STATE OF NORTH CAROLINA  
DEPARTMENT OF TRANSPORTATION

In Reply Refer To  
Application 2180 & 2181

Our investigation of your STAA reasonable access route request number 2180 and 2181 for SE Independent Delivery Services, Inc. is complete. The routes requested are as follows:

New Highway 2180

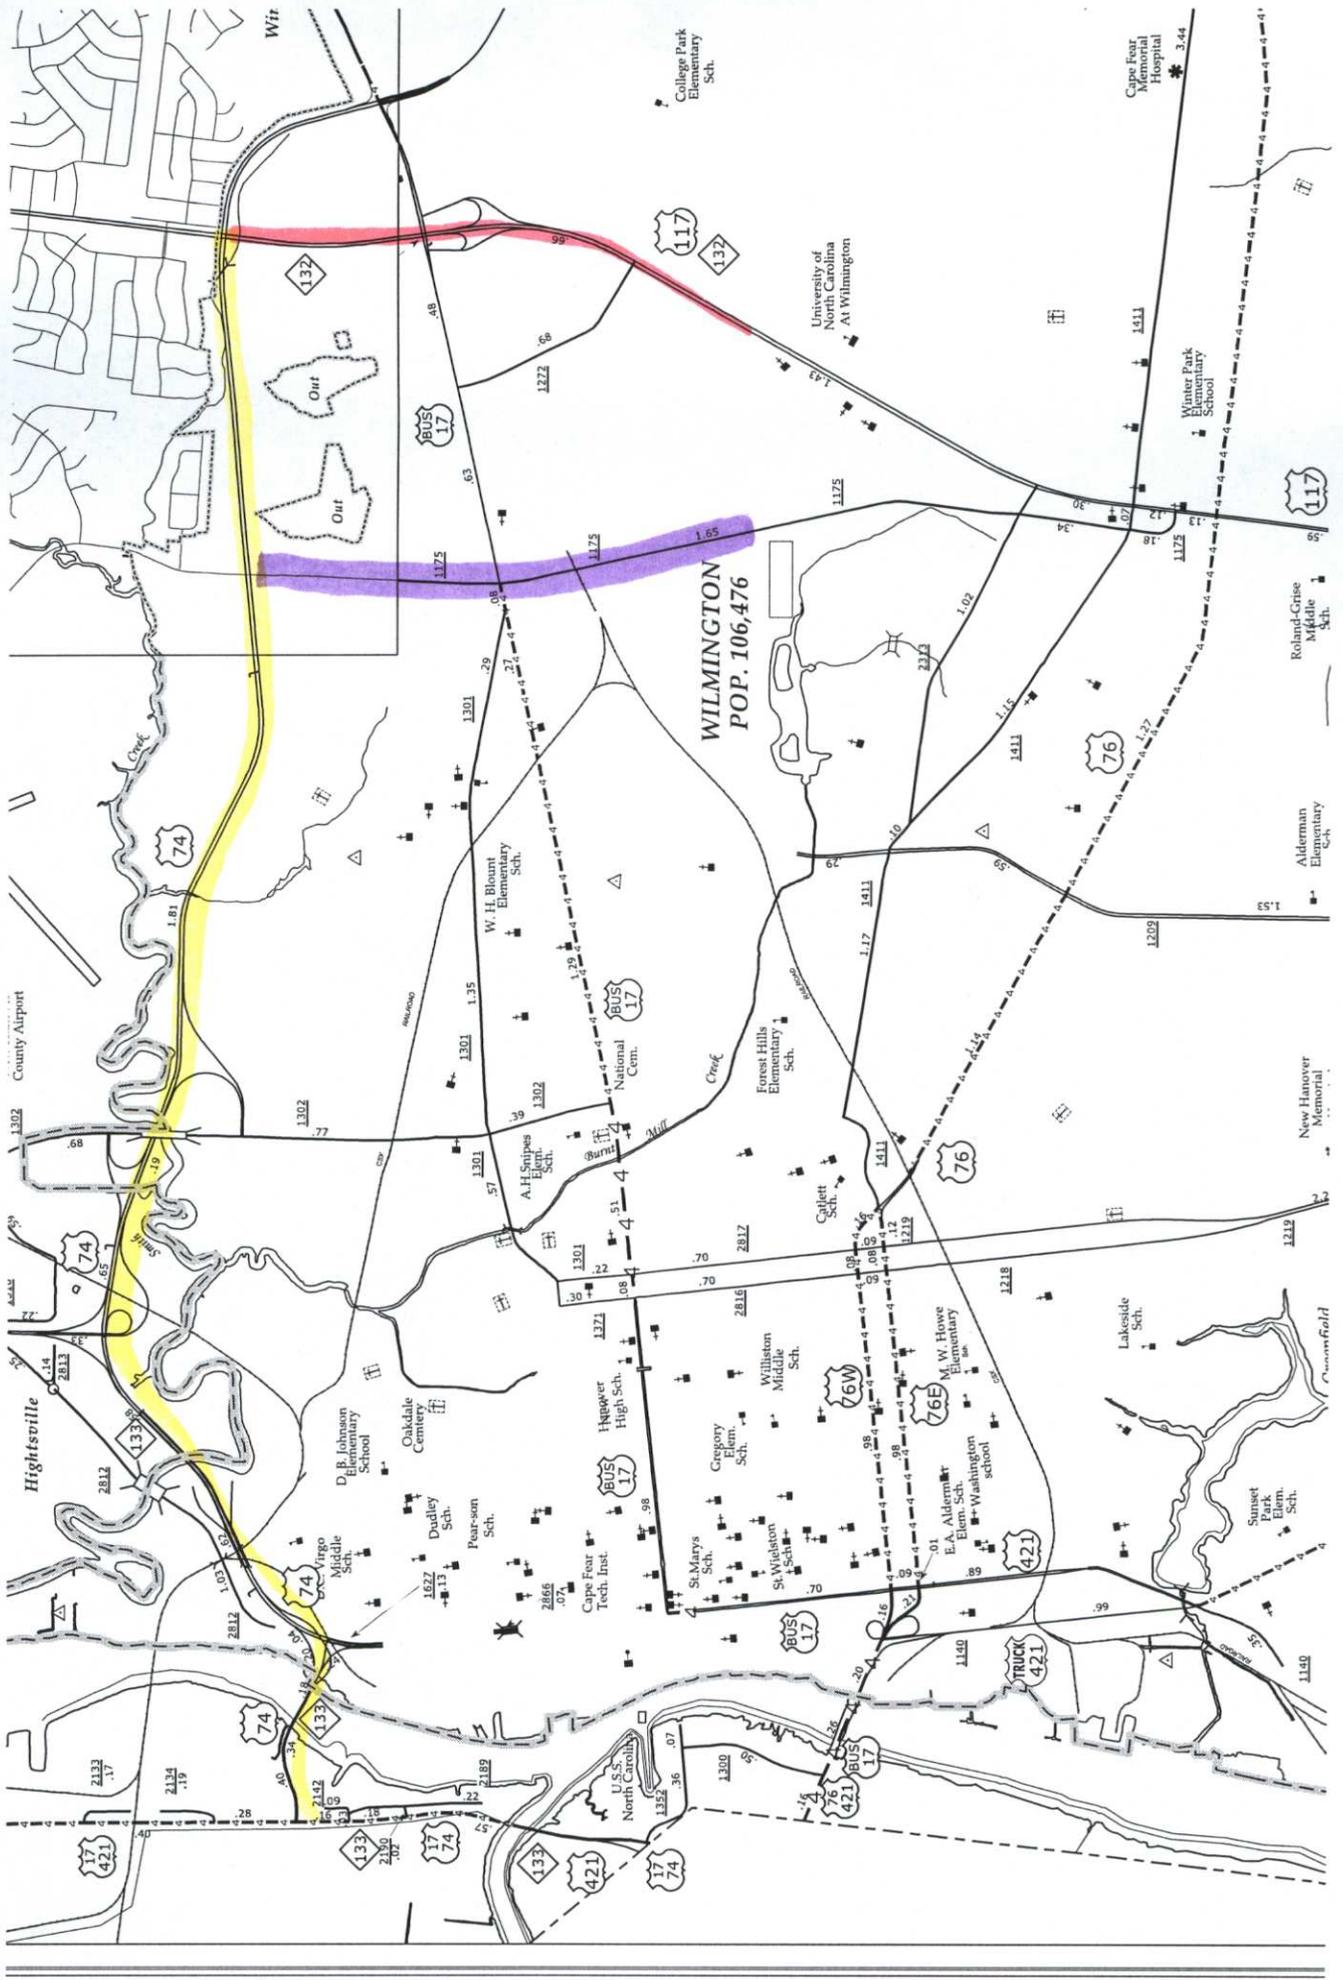
For Reasonable Access Request No. 2180, we have found this route to be acceptable by current traffic engineering standards and hereby grant approval for your firm to run twin-trailers along this route contingent on the following.

- 1) The exit route for this request will need to be revised to include Randall Parkway and SR 1175 (Kerr Avenue). The Rooms To Go facility is located in the northwestern quadrant of the intersection with US 117/NC 132 (College Road) and Randall Parkway (non-system City of Wilmington street). During the investigation, it was discovered that there is a future project scheduled for Randall Parkway that will make it a divided facility. This will prevent any left turns from the loading area of Rooms To Go. In the future, all trucks unloading will have to make a right turn onto westbound Randall Parkway for 0.5 mile to SR 1175 (Kerr Avenue). A right will have to be made onto northbound SR 1175 (Kerr Avenue) and then will have to travel approximately 1.5 miles back to US 74.

- 2) Randall Parkway is a non-system street maintained by the City of Wilmington. You will need to obtain approval from the City of Wilmington to use this section of roadway.

- 3) All loading operations shall be performed on Rooms To Go property. No parking or loading operations are to be performed in the roadway.
